Texas Commission on Environmental Quality Waste Permits Division Correspondence Cover Sheet

Facility Name: Coletto Creek Power Station

RE: Response to EMAIL NOD New Registration No. CCR116
Coletto Creek Power LLC - Fannin, Goliad County
Industrial Solid Waste Registration No. 31911
EPA Identification No. TXD000836999
Tracking No. 27262899; RN100226919/CN605521988

Table 1 - NOD Summary and Response
 Registration No. CCR116 - Coletto Creek Power LLC
 Application Deficiencies - Technical NOD 2

PROJECT NO. 31404097.007
 REV. 0
 FIGURE 2

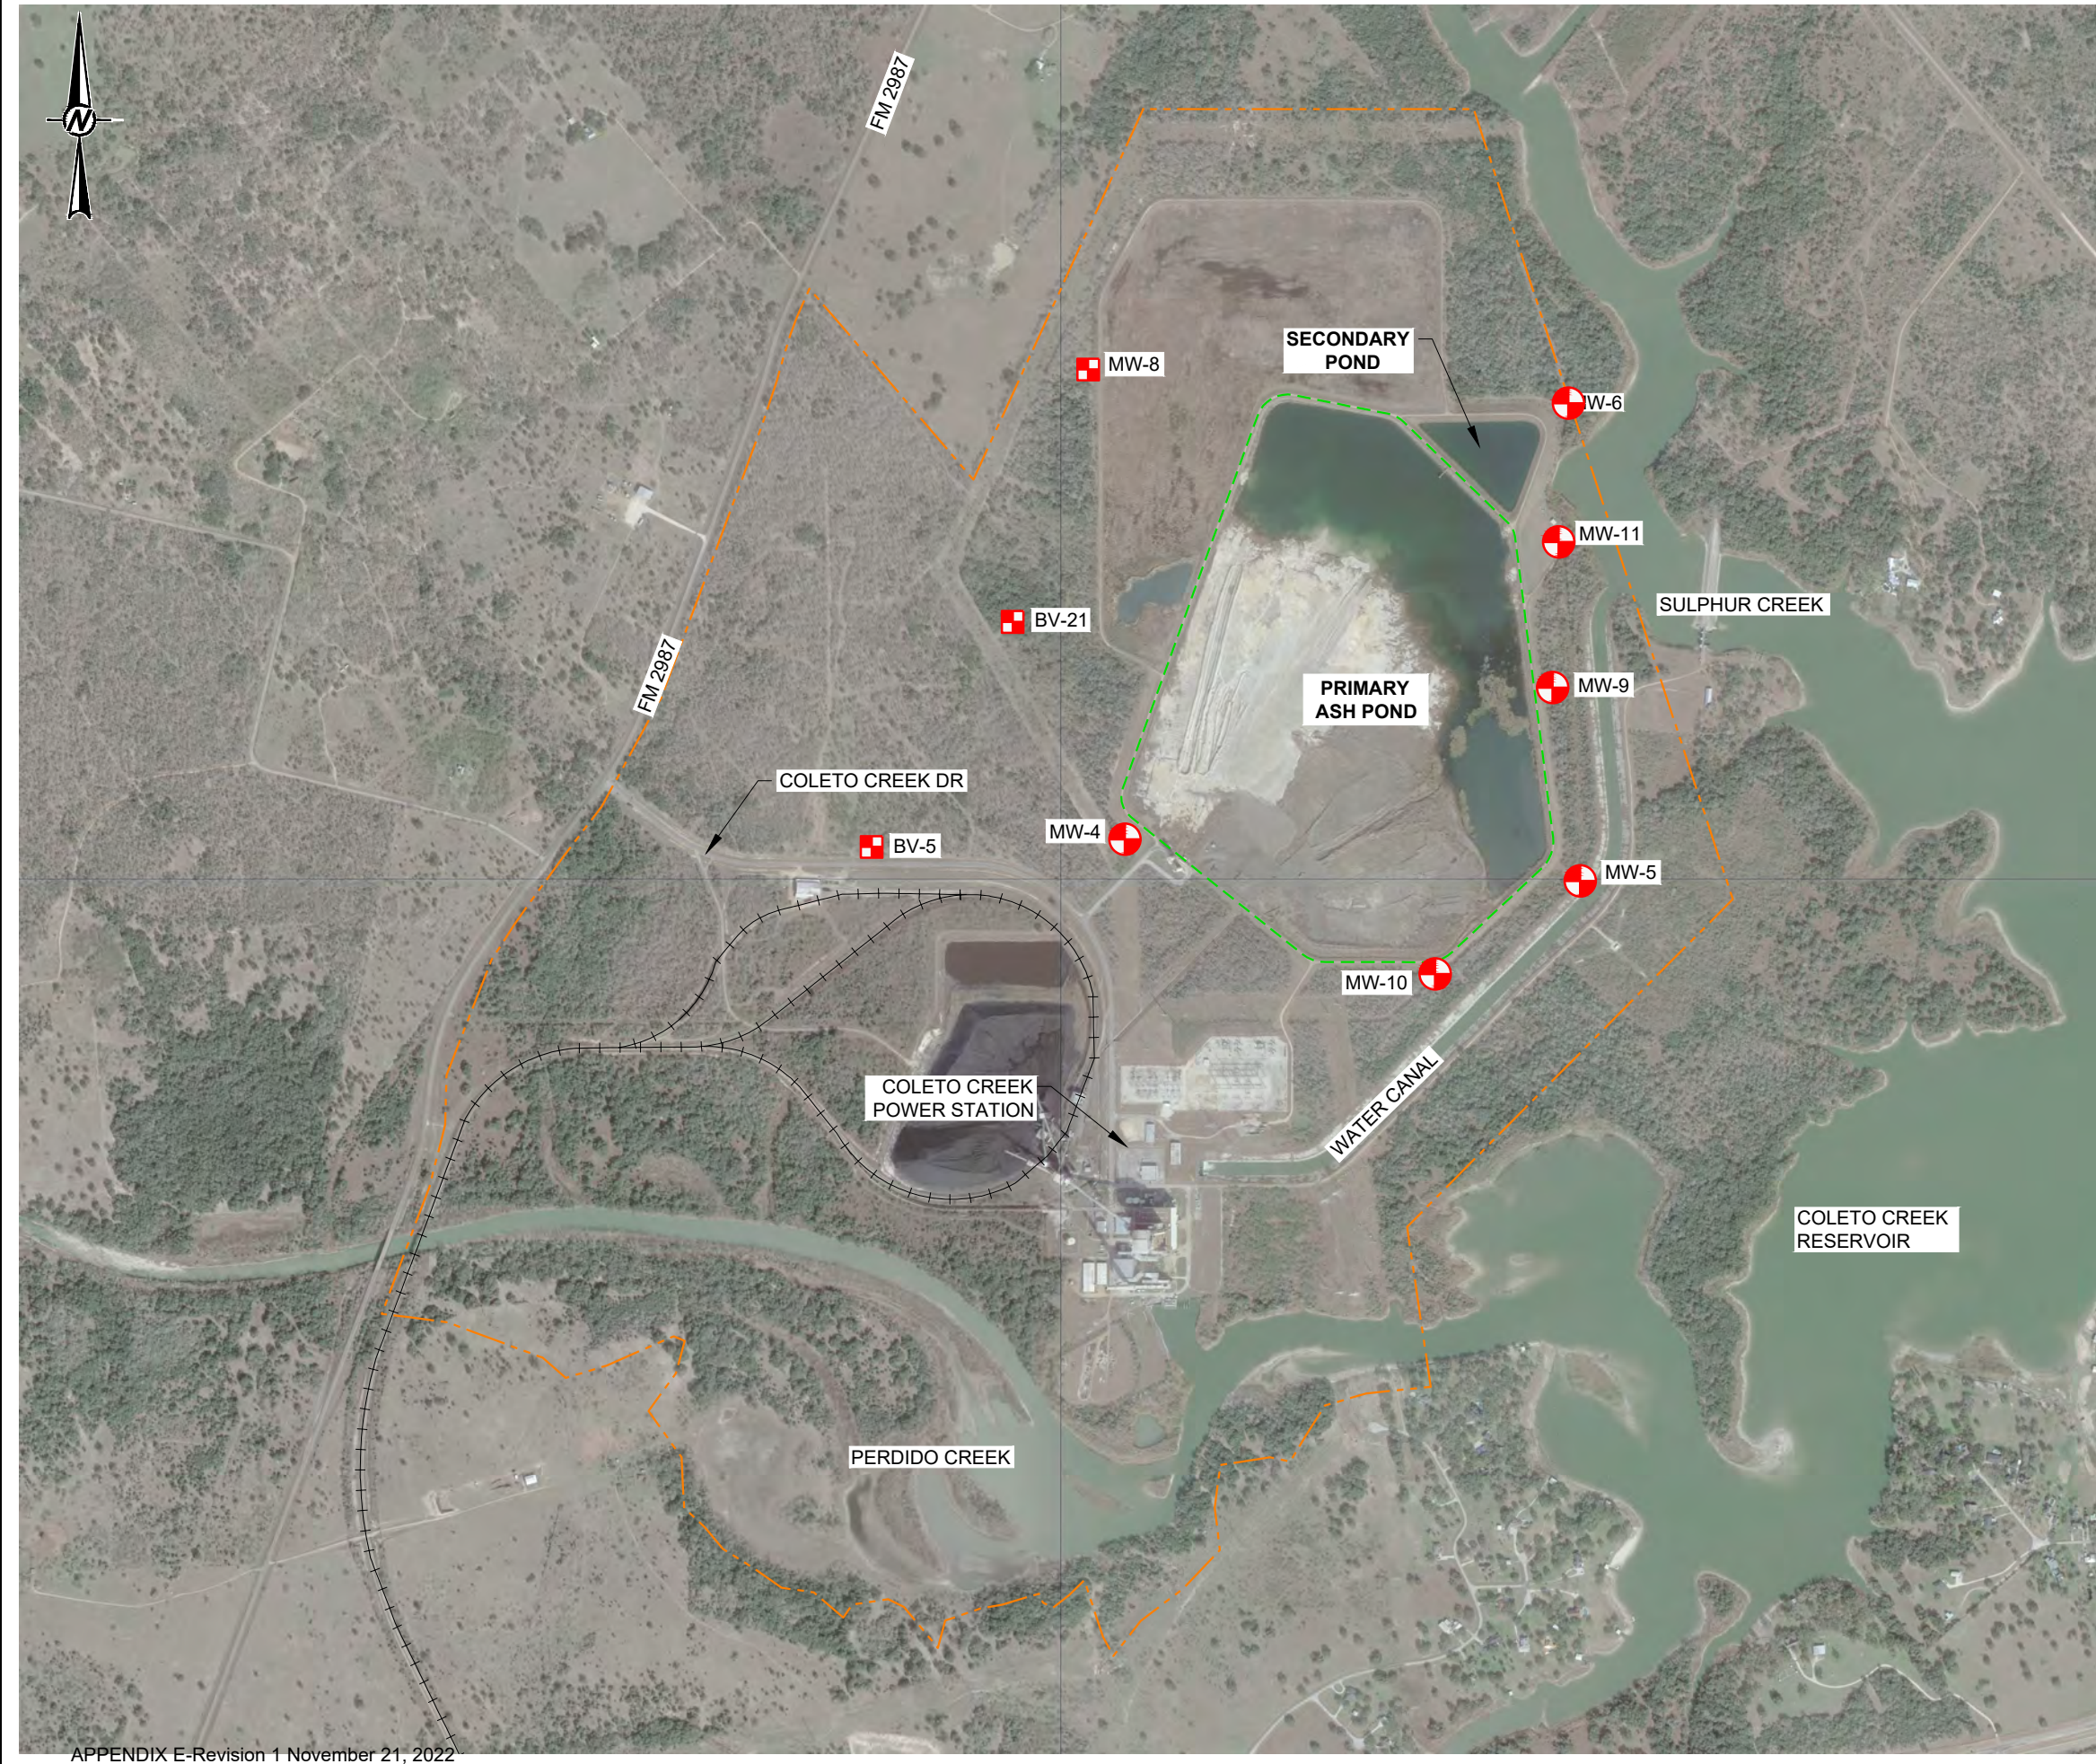
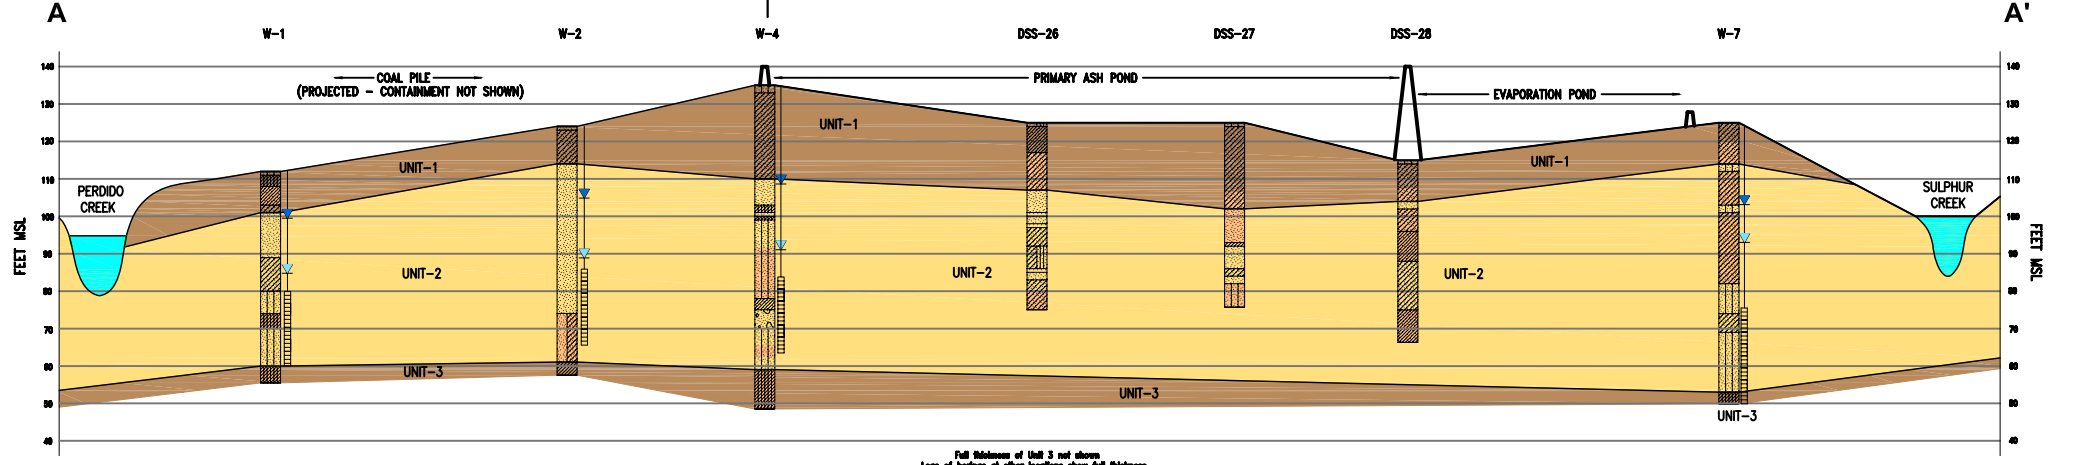
10	VI	VI.28	Appendix E Groundwater Monitoring Plan (Pages 845, 871, and 888)	Application instructions	Provide a P.G. or P.E. signed and sealed cover page and Figure 2 - site plan map.	The "Groundwater Monitoring Plan-Revision 1" has been revised to contain a signed and sealed signature page and sealed Figure 2. The revised Groundwater Monitoring Plan is located in Appendix E of the application.
11	VI	VI.29	Table VI.C-1	Application Instructions <u>40 CFR 257.94 Appendix III</u>	Add and complete attached "Table VI.C-1 – Groundwater Detection Monitoring Parameters.", if applicable. This table was inadvertently omitted in the application form.	Table VI.C-1 inserted into application. Per application section VI.29, this table is not applicable since no units are in detection monitoring.
12	VI	VI.30.H	Table VI.D-2	Application Instructions	Replace title of "Table VI.D.2 – Groundwater Detection Monitoring Parameters" with "Table VI.D-2 – Groundwater Assessment Monitoring Parameters" and complete if applicable.	Table VI.D-2 has been updated with assessment monitoring parameters.

PROJECT NO. 20142034 REV. 0 FIGURE 1

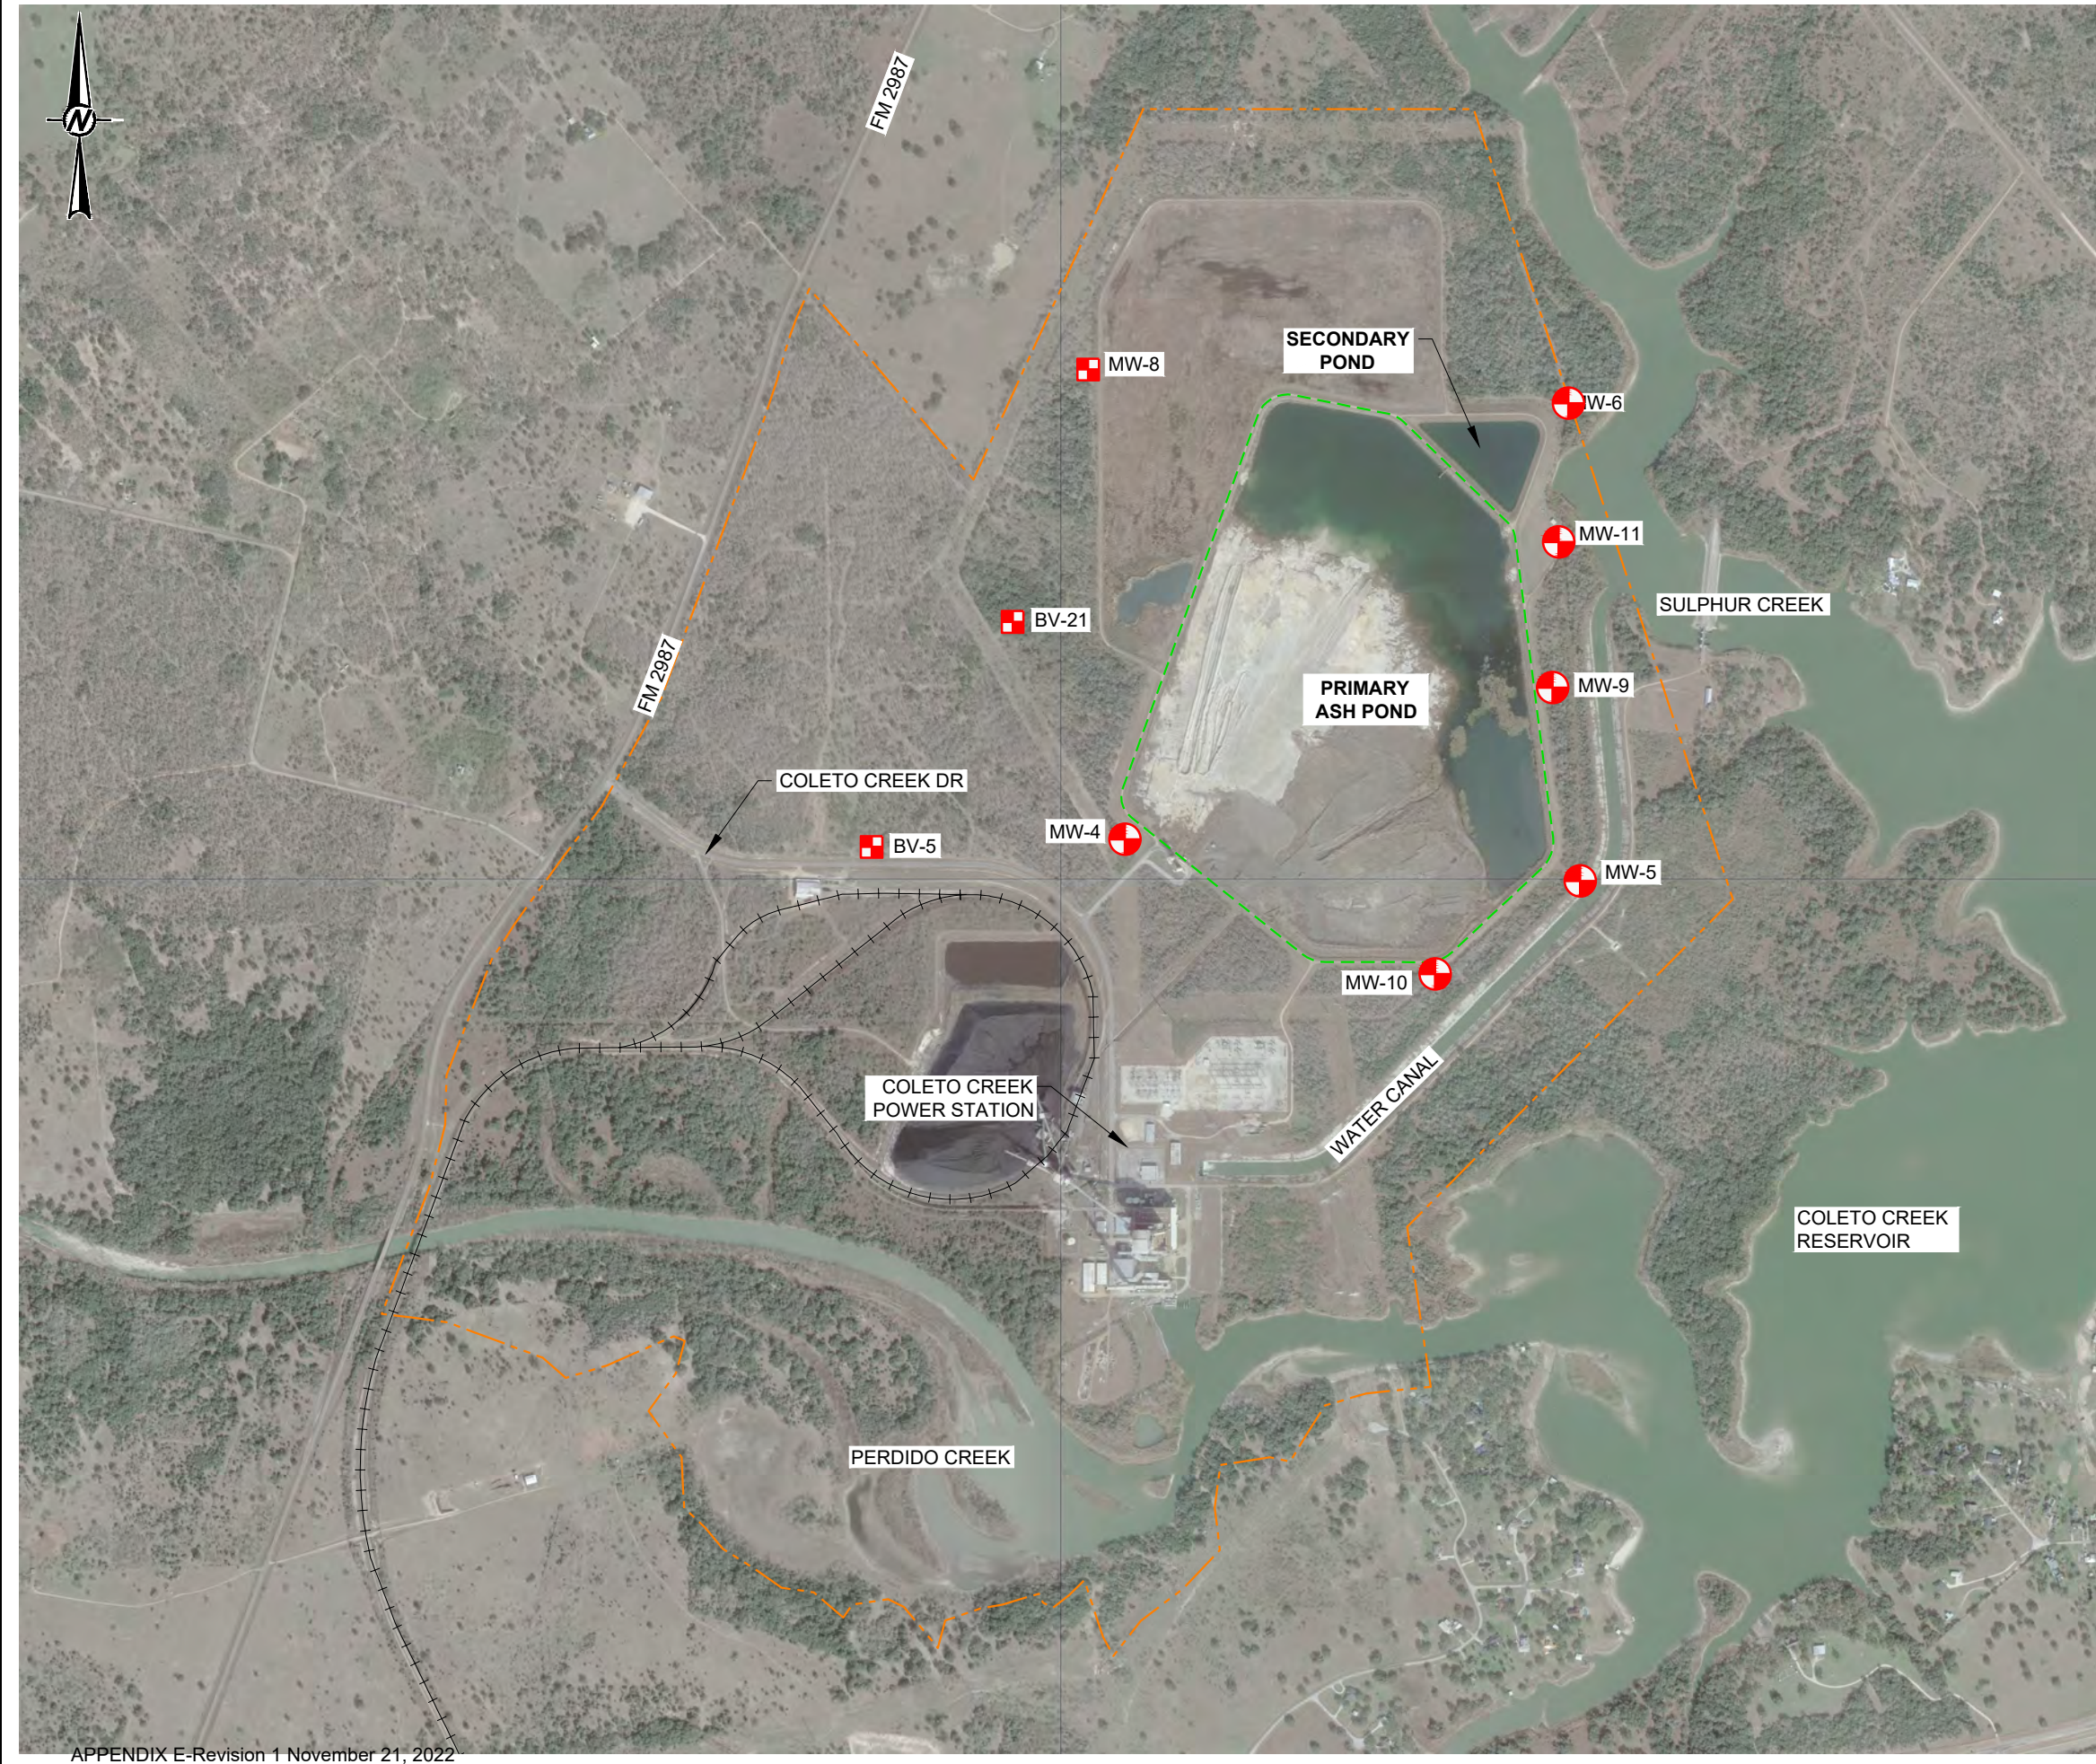
13	VI	VI.30	2021 Annual Groundwater Monitoring and Corrective Action Report	<u>30 TAC §352.931;</u> 40 CFR 257.90(e), 257.93;	a.) Provide analytical Data for the 2021 Groundwater Monitoring and Corrective Action Report. b.) Provide a P.E. or P.G. signed and sealed copy of Figure 1 of report.	The "2021 Annual Groundwater Monitoring and Corrective Action Report-Revision 1" has been revised to include analytical lab data and signed and sealed Figure 1. The revised report is in APPENDIX E.
